# UNITED STATES PATENT AND TRADEMARK OFFICE

APPLICATION NO.	FILING DATE	FIRST NAMED INVENTOR	ATTORNEY DOCKET NO.	CONFIRMATION NO.
10/626,361	07/23/2003	Jeremy A. Davis	200210054-1	1224

<b>Office Action Summary</b>	<b>Application No.</b> 10/626,361	<b>Applicant(s)</b> DAVIS, JEREMY A.	
	<b>Examiner</b> William H. Rodriguez	<b>Art Unit</b> 3746

## DETAILED ACTION

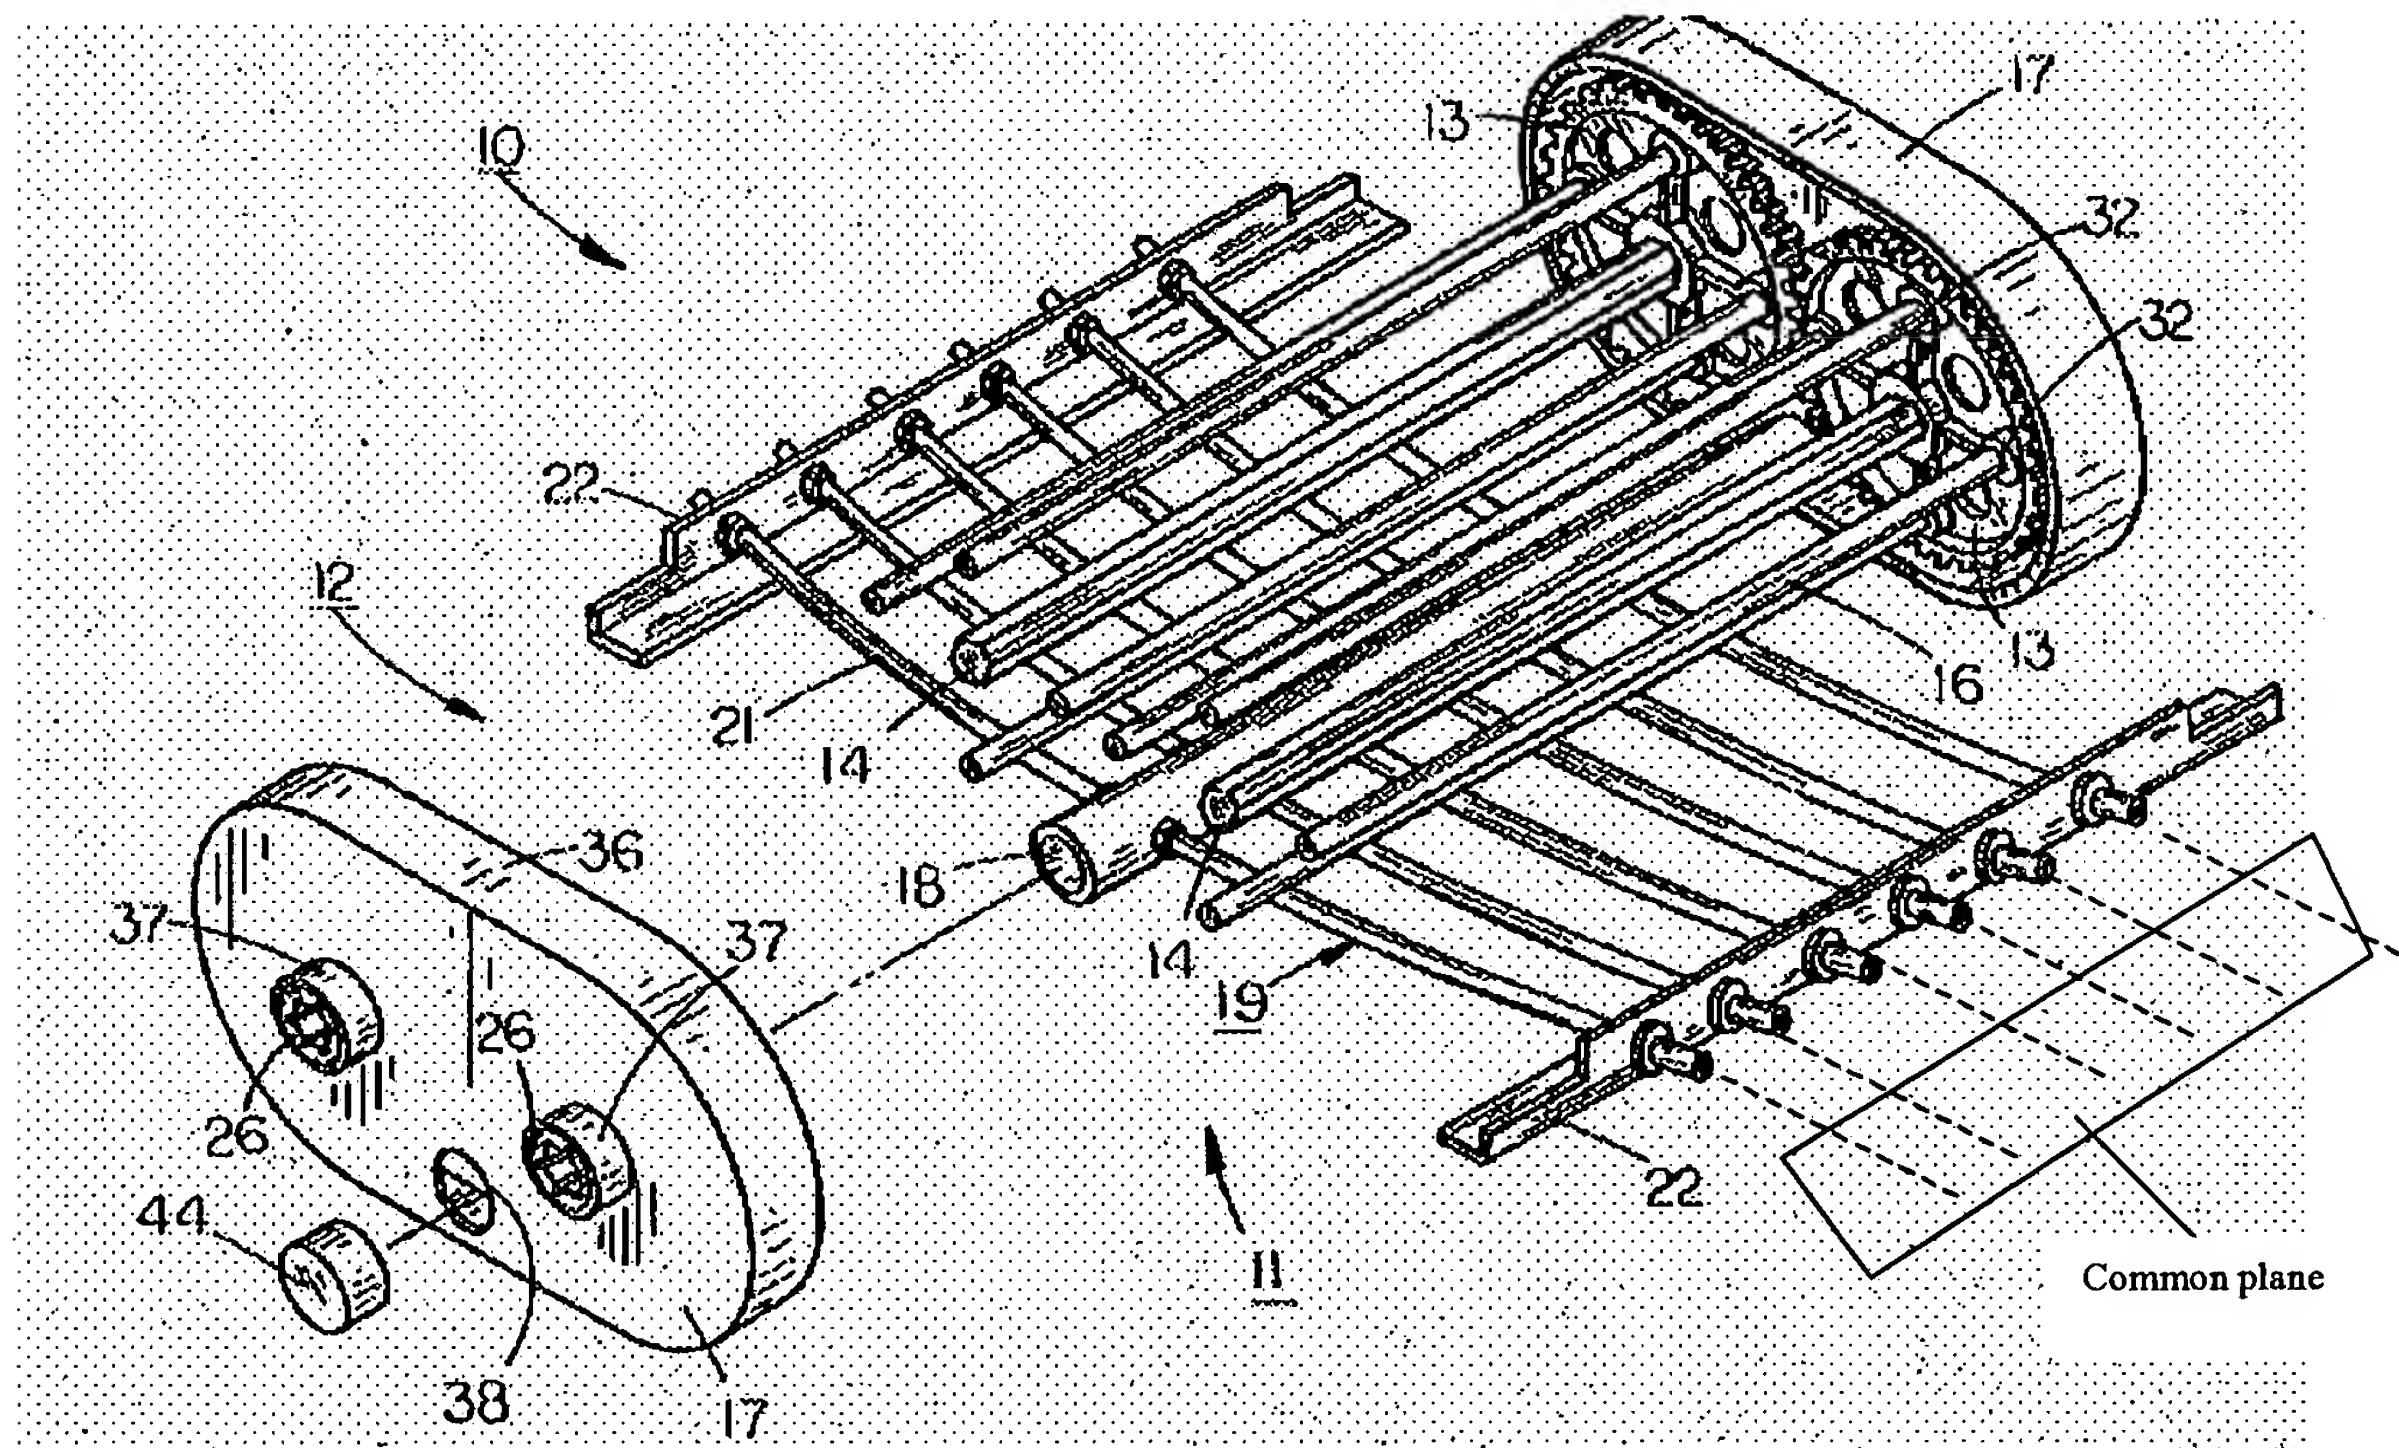
3. Claims 1-3, 5, 13-15 and 17 are rejected under 35 U.S.C. 102(b) as being anticipated by **Schartz (US 4,522,570)**.

With respect to claim 1, **Schartz** teaches a pump having a rotary portion 16 which compels the movement of a fluid by peristaltic compression of resilient tubing 19 containing the fluid, a tube component comprising a plurality of adjacent resilient tubes; a web 22 interconnecting the adjacent resilient tubes. See particularly Figure above.

With respect to claim 2, **Schartz** teaches that the resilient tubes has a cross-sectional centerline occurring in a common plane, and the web interconnects the resilient tubes in an area outside of the common plane. See particularly Figure above.

With respect to claim 3, **Schartz** teaches that the rotary portion of the pump includes a rotary area of pump operation, and the web is outside the rotary area of pump operation. See particularly Figure above:

With respect to claim 13, **Schartz** teaches a method of assembling a pump having a rotary portion 16 which compels the movement of a fluid by peristaltic compression of resilient tubing 19 containing the fluid comprising the following: providing a plurality of adjacent resilient tubes, and interconnecting the adjacent resilient tubes with a web 22. See particularly Figure above.

With respect to claim 14, **Schartz** teaches that providing a plurality of adjacent resilient tubes comprises providing each of the resilient tubes with a cross-sectional centerline occurring in a common plane, and interconnecting the adjacent resilient tubes with a web comprises interconnecting the resilient tubes in an area outside of the common plane. See particularly Figure above.

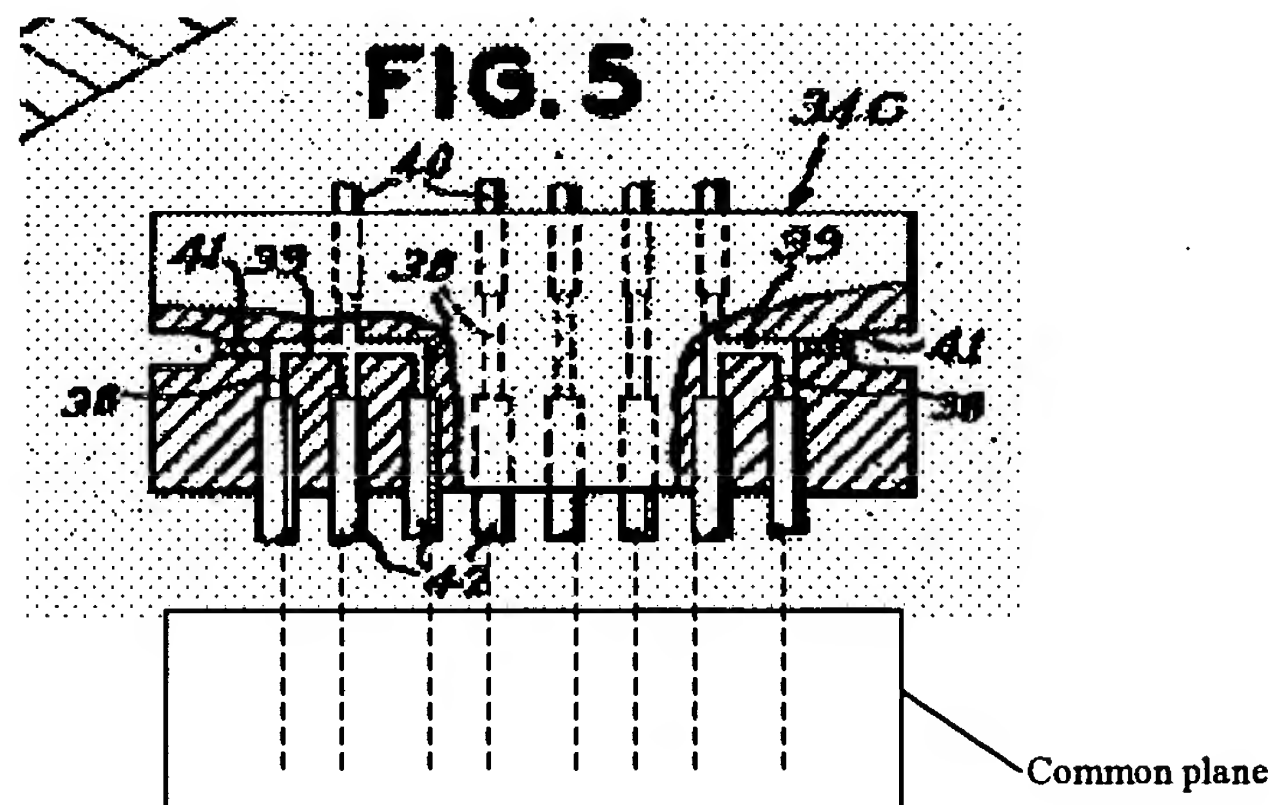
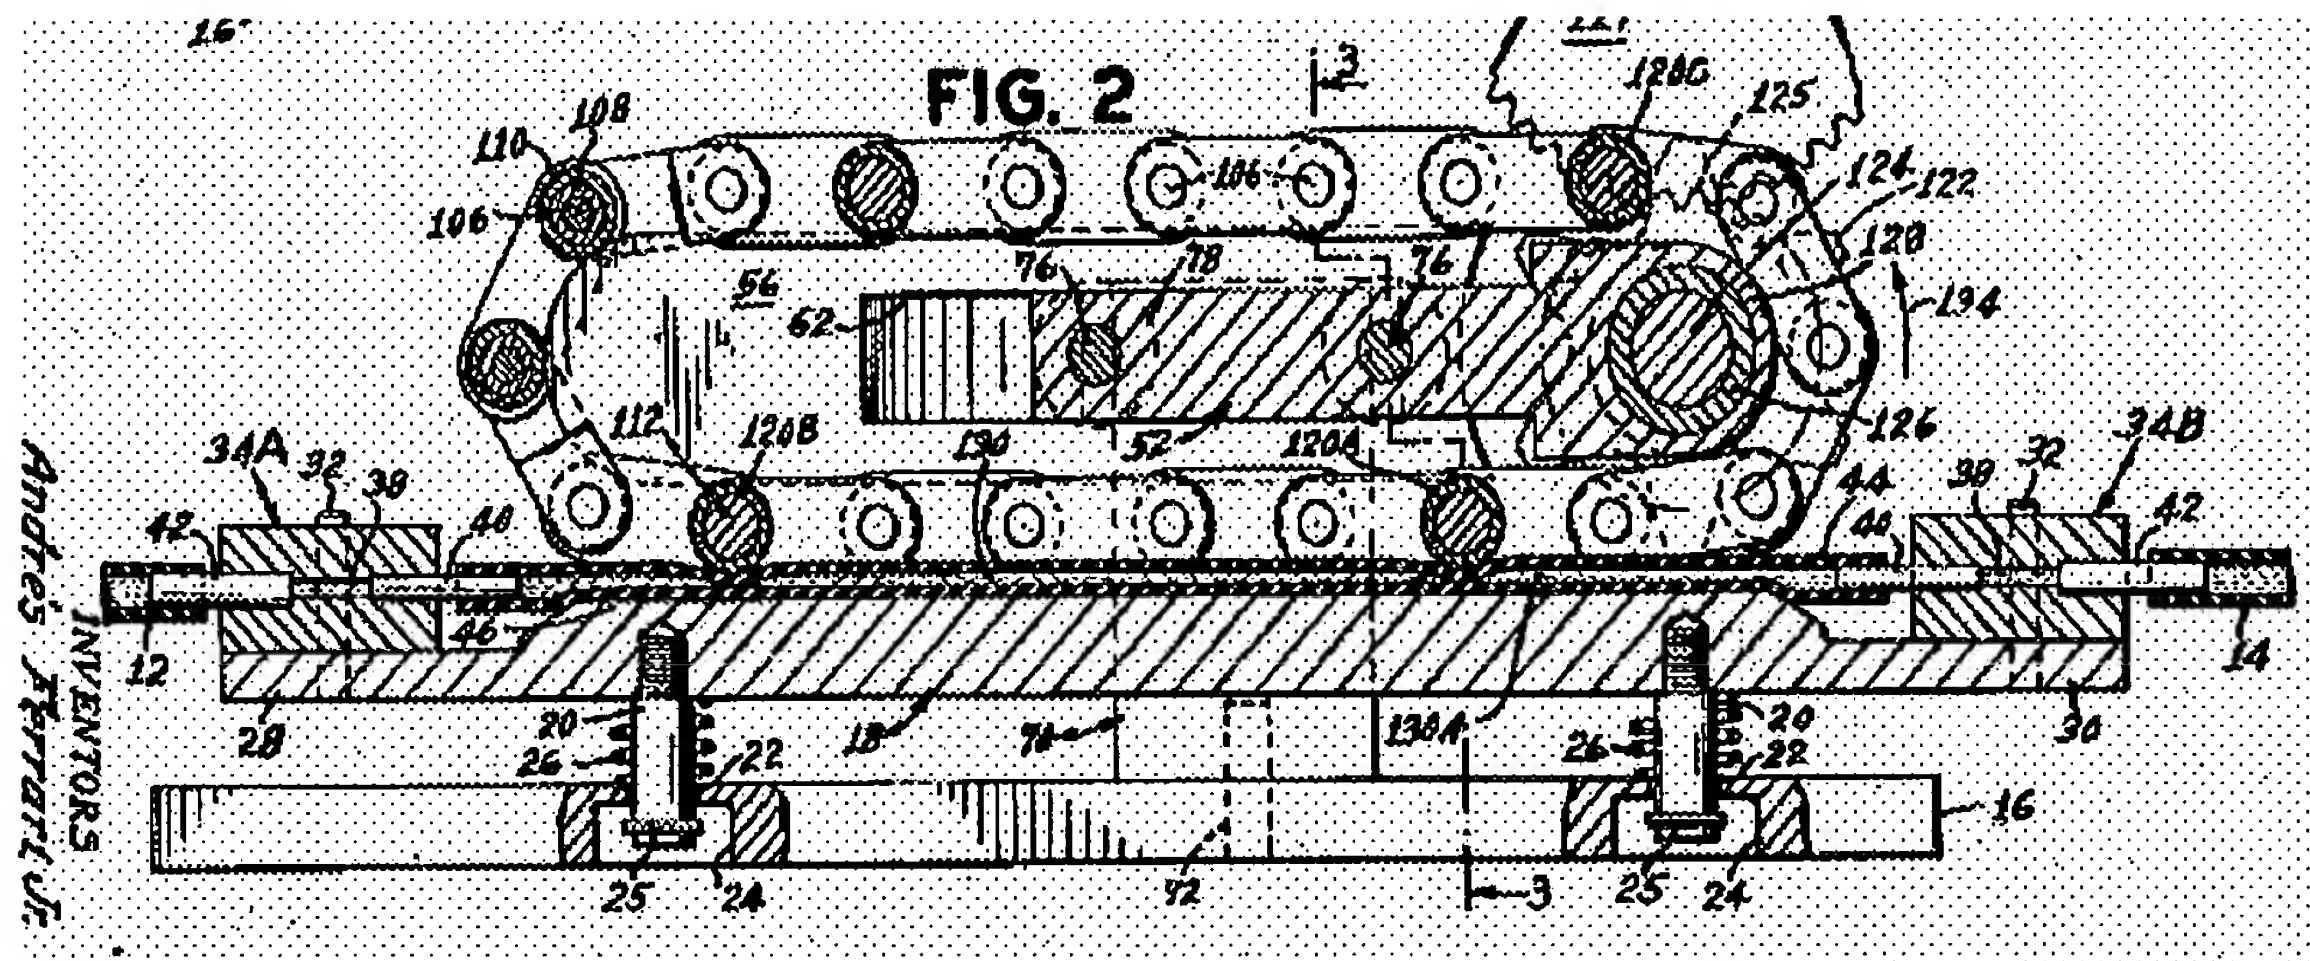
4. Claims 1-3 and 13-15 are rejected under 35 U.S.C. 102(b) as being anticipated by Ferrari et al. (US 2,865,303).

With respect to claim 1, Ferrari teaches a pump having a rotary portion 120 which compels the movement of a fluid by peristaltic compression of resilient tubing (44, 40, 42) containing the fluid, a tube component comprising a plurality of adjacent resilient tubes; a web 34C interconnecting the adjacent resilient tubes. See particularly Figures 2, 5 above and column 4 lines 59-71 of Ferrari.

With respect to claim 2, **Ferrari** teaches that the resilient tubes has a cross-sectional centerline occurring in a common plane, and the web interconnects the resilient tubes in an area outside of the common plane. See particularly **Figure 5** above.

With respect to claim 3, **Ferrari** teaches that the rotary portion of the pump includes a rotary area of pump operation, and the web is outside the rotary area of pump operation. See particularly **Figures 2, 5** above.

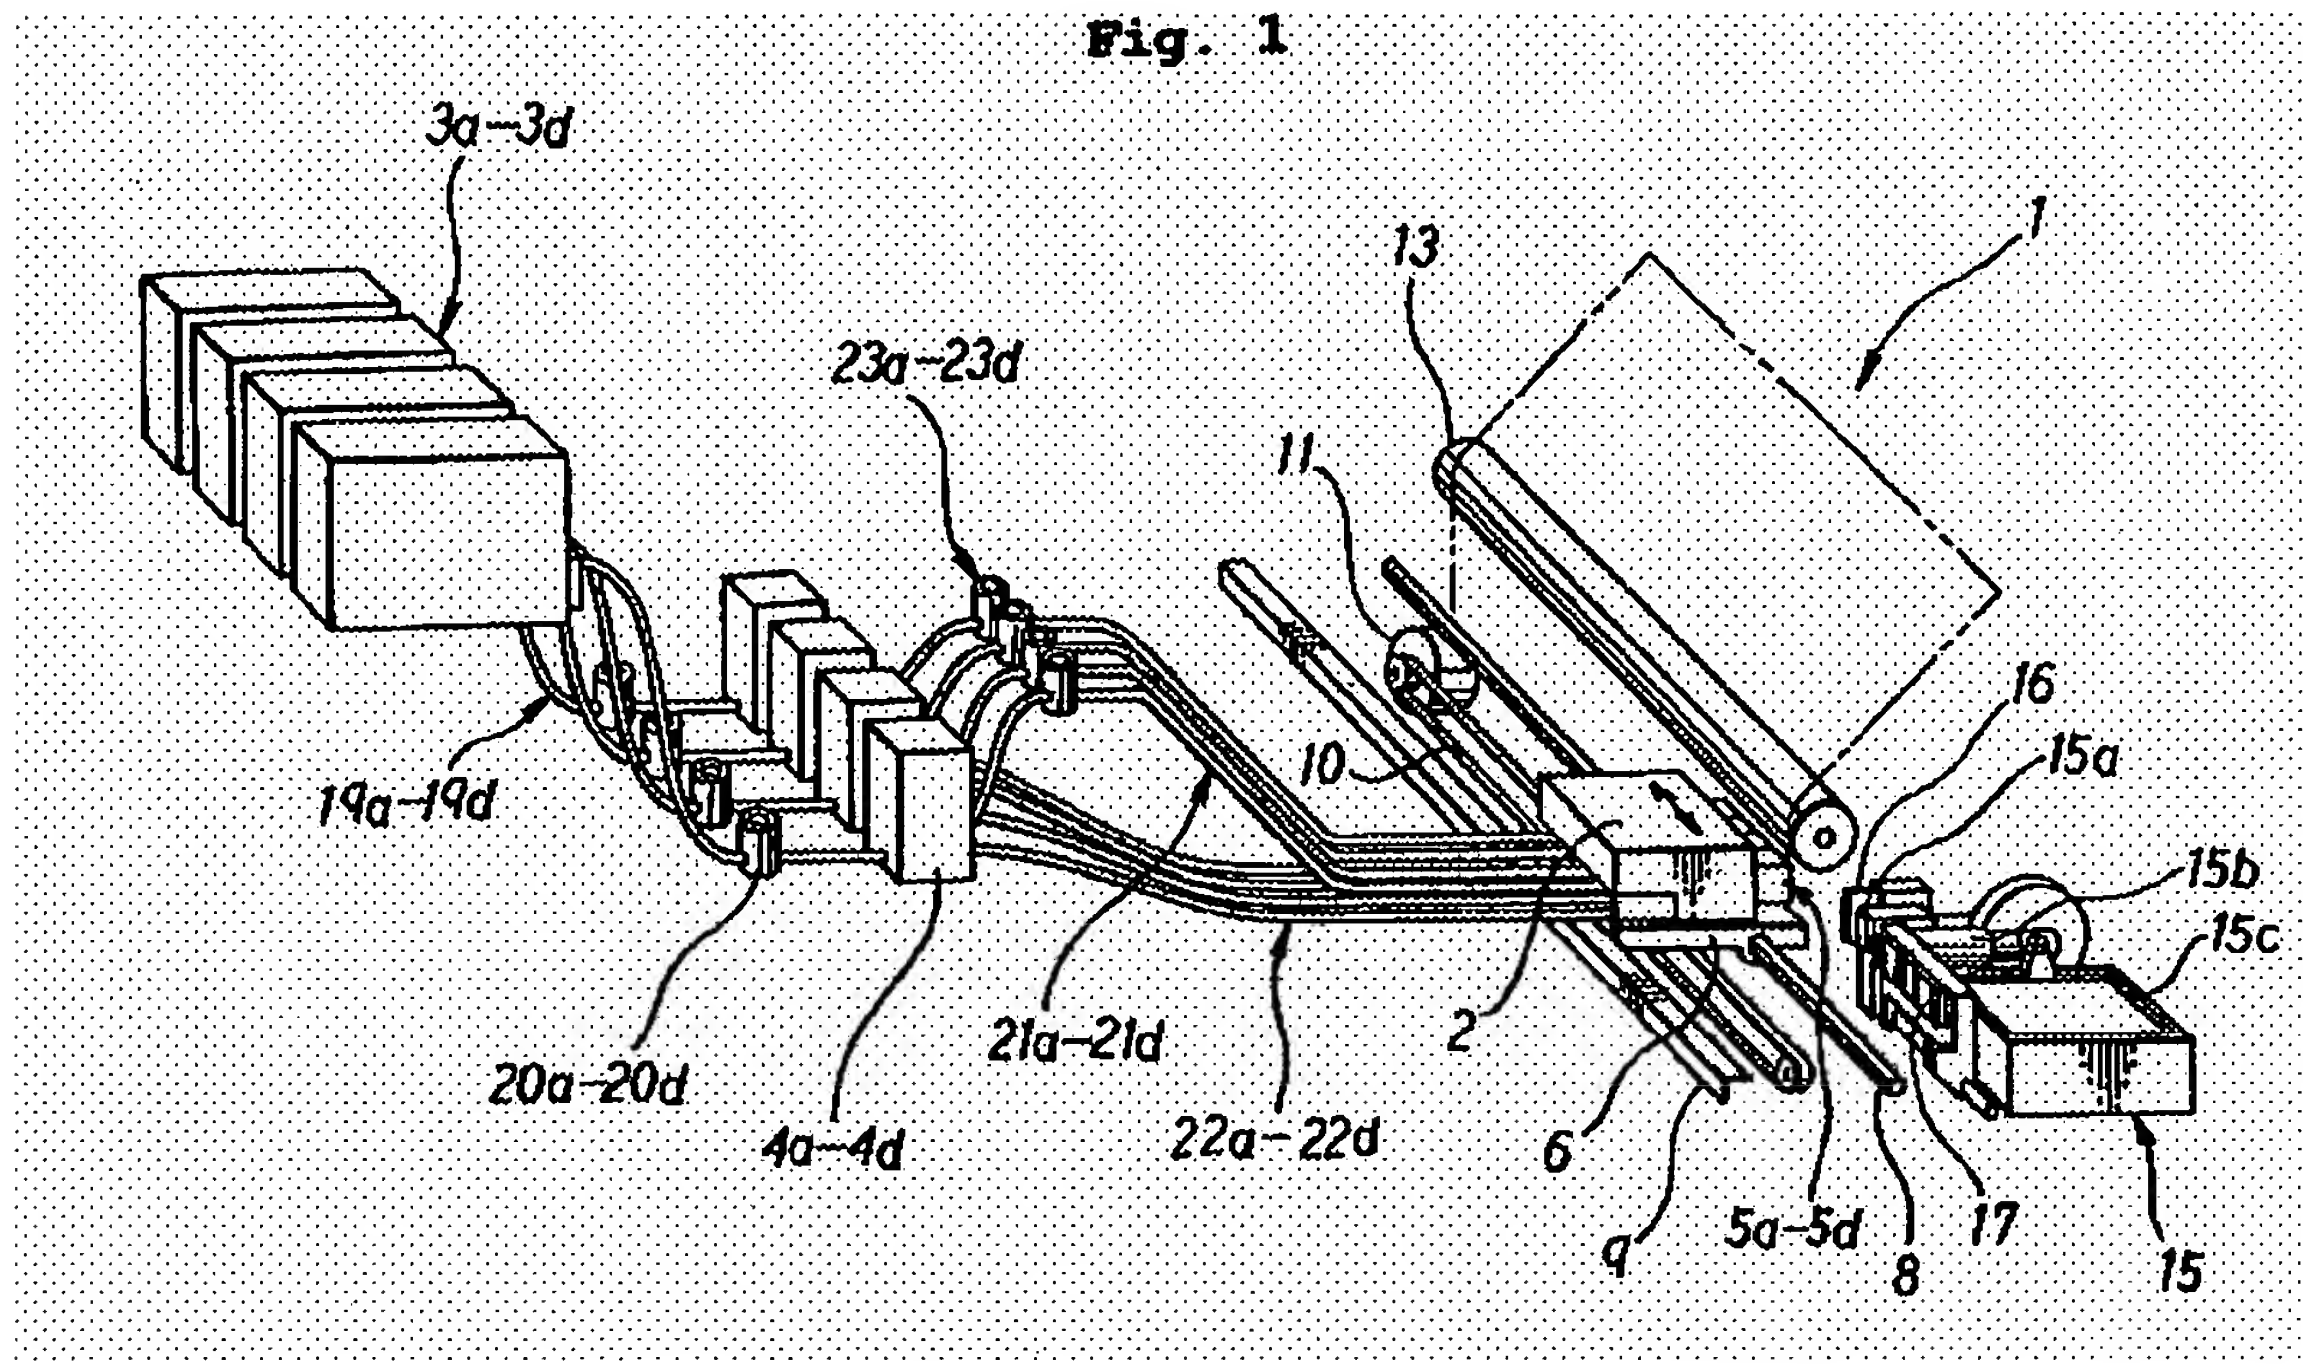
With respect to claim 13, **Ferrari** teaches a method of assembling a pump having a rotary portion 120 which compels the movement of a fluid by peristaltic compression of resilient tubing (40, 42, 44) containing the fluid comprising the following: providing a plurality of adjacent resilient tubes, and interconnecting the adjacent resilient tubes with a web 34C. See particularly **Figures 2, 5** above and column 4 lines 59-71 of Ferrari.

With respect to claim 14, **Ferrari** teaches that providing a plurality of adjacent resilient tubes comprises providing each of the resilient tubes with a cross-sectional centerline occurring in a common plane, and interconnecting the adjacent resilient tubes with a web comprises interconnecting the resilient tubes in an area outside of the common plane. See particularly **Figure 5** above.

With respect to claim 15, **Ferrari** teaches that the rotary portion of the pump includes a rotary area of pump operation, and interconnecting the adjacent resilient tubes with a web comprises interconnecting the resilient tubes in an area outside the rotary area of pump operation. See particularly **Figures 2, 5** above.
